Date: Thursday, November 10, 2022
Project: Lots 1-8 and Dedicated ROW for Buckaroo Ct All of TAB Industrial Park
To: Lisa Schieffer, City Administrator
From: HDR, Inc
Subject: Preliminary Plat - Plan Review

Final Plat Review

Lots 1-8 and Dedicated Public Right of Way for Buckaroo Court All of TAB Industrial Park

REVISIONS
 DATE
 FINAL DESIGN
 10/26/2022
 10-1000-4
 SHEET
 3.0
 TITLE LOT LAYOUT PLAN
 SCALE: 1"=80'
 NORTH ARROW
 0 40 80
 FEET
 SHEET
 3.0

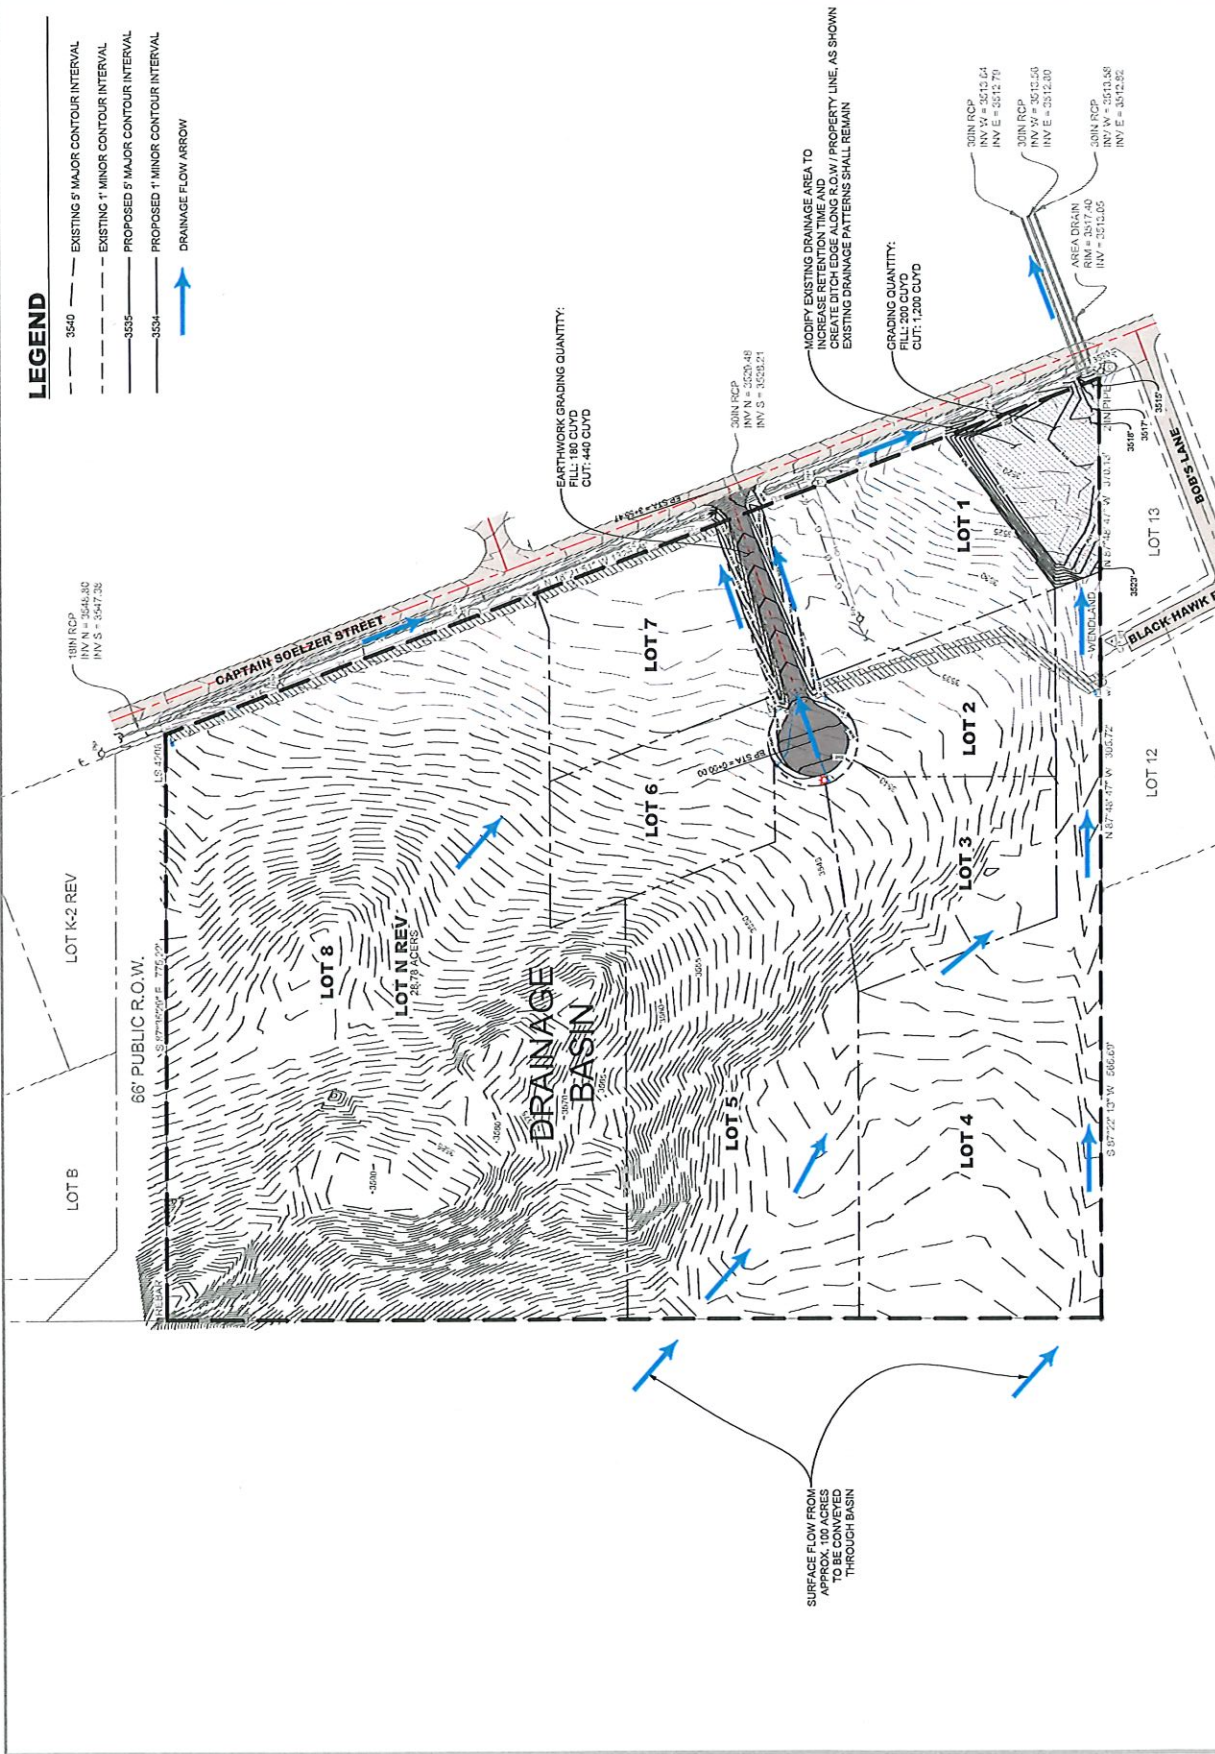
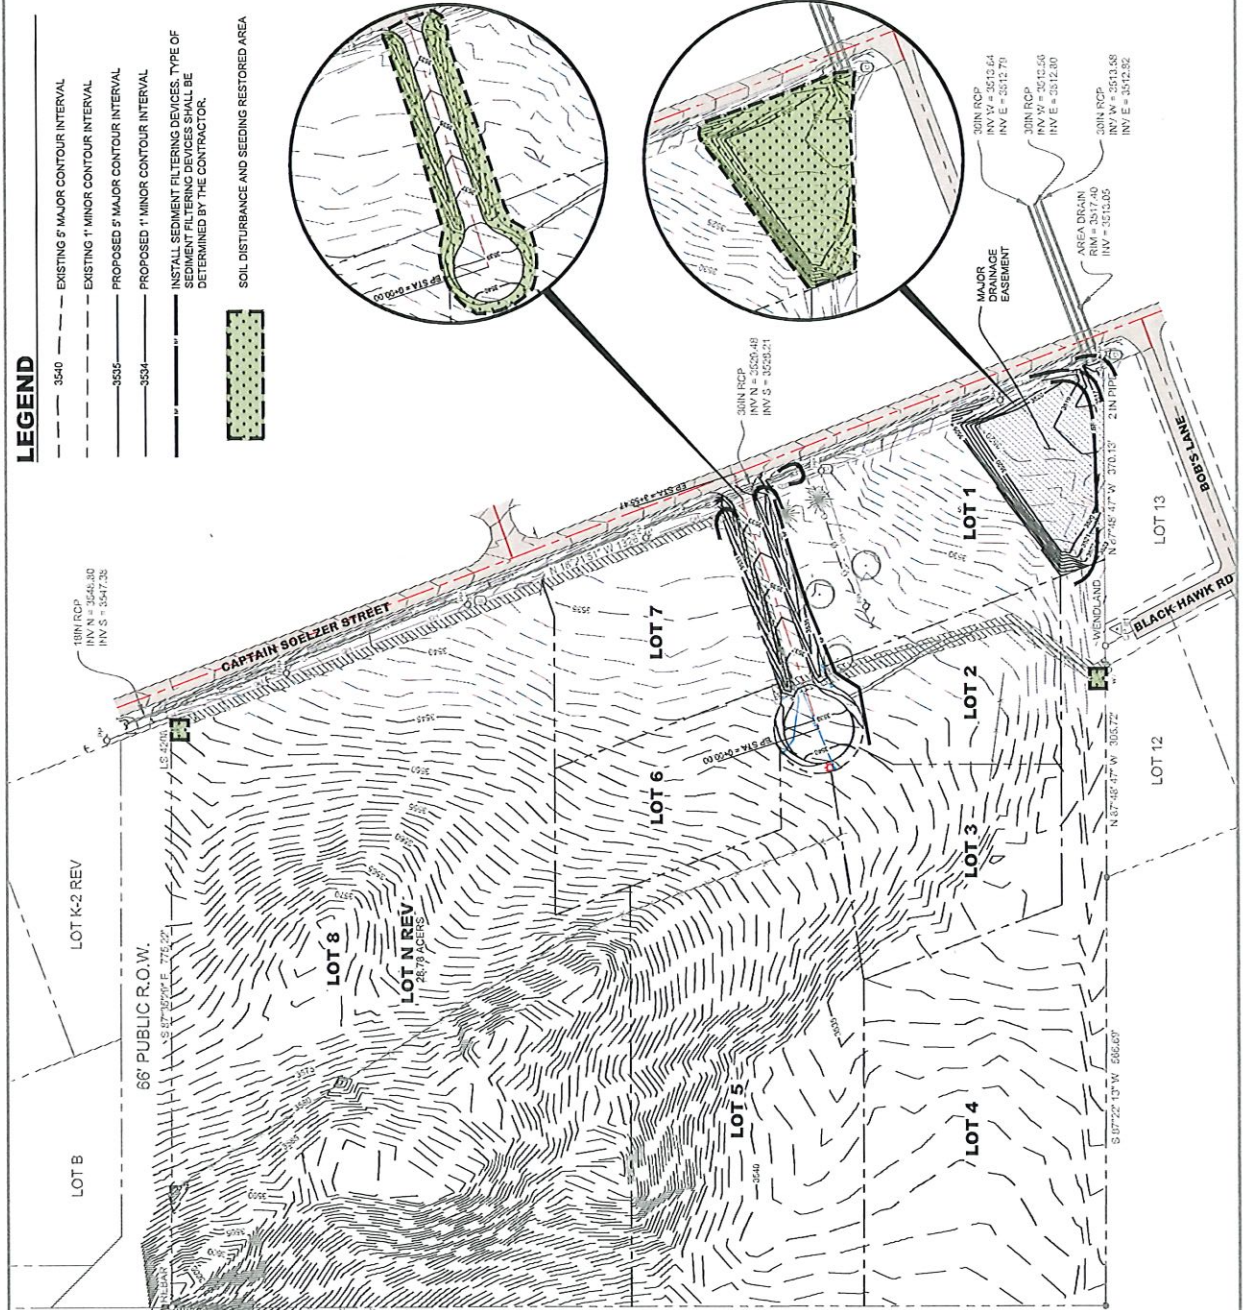
Bearings Distances of the Perimeter do NOT close by 4 feet

Buckaroo Crt. ROW is not a Parallel width, bearing of L1 is different than the north line of the dedicated ROW.

Why are bearing and distance not provided to found Wendland monument (at Black Hawk Rd. CL).

Acreages shown for the proposed lots and ROW comes to 28.715 Acres, this doesn't match previous plat of Lot N.

For commercial roadways Summerset IDCM requires a minimum ROW width of 70'.

TITLE PLAN & PROFILE STA.
0+00 - 3+37.07

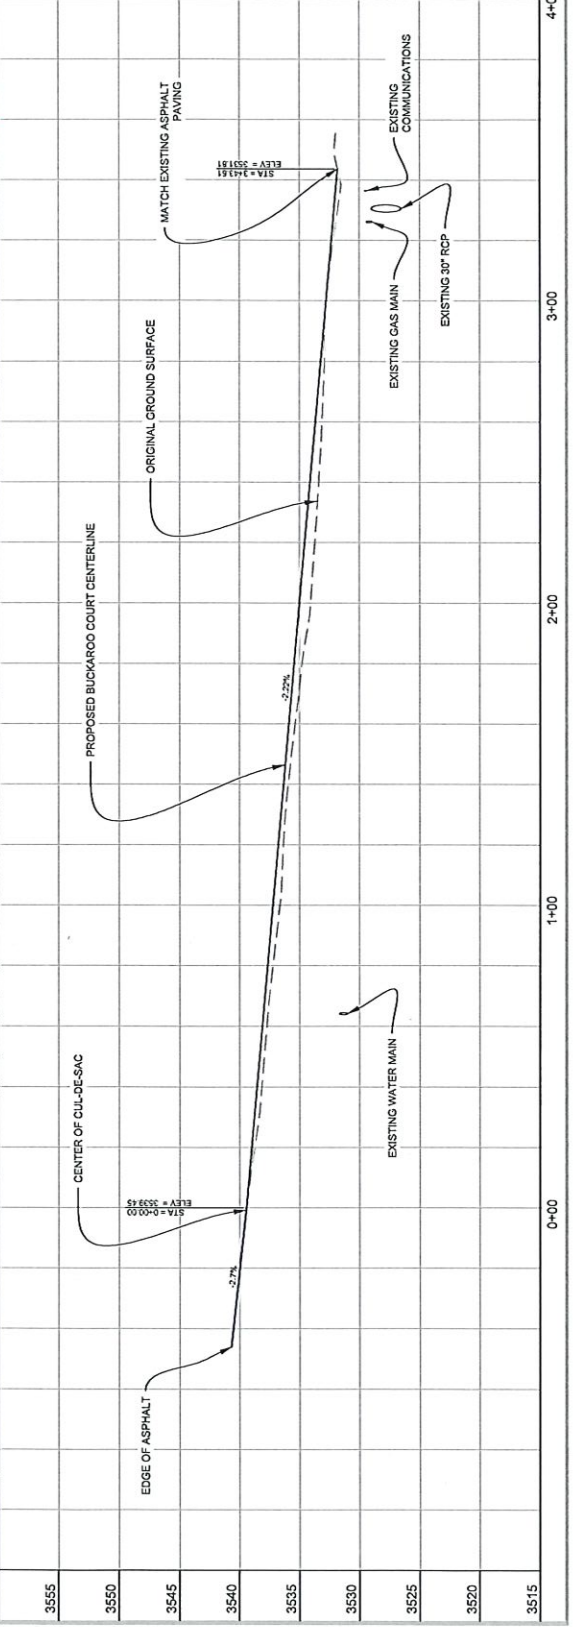
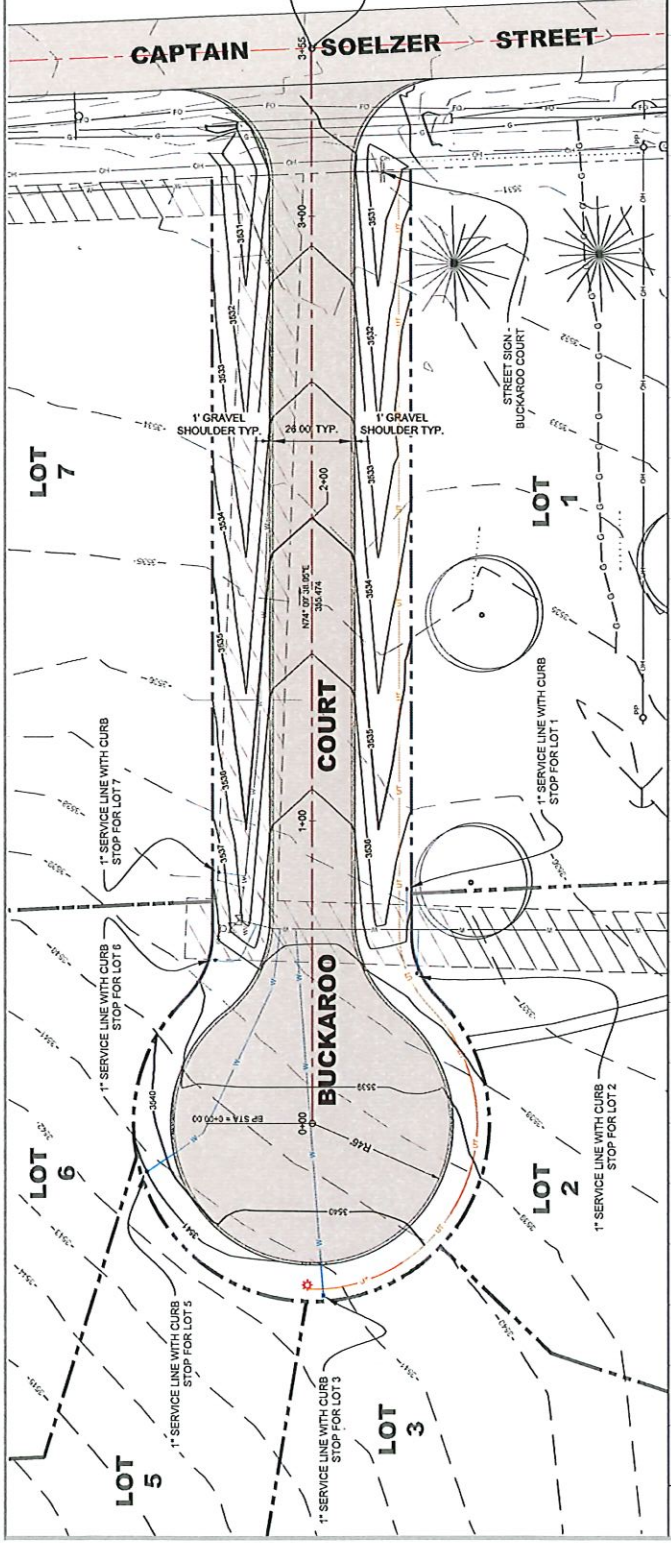
4. Proposed street section does not meet Summerset IDCM. For a commercial area IDCM requires an urban section (26' min. street width with curb and gutter and sidewalk).
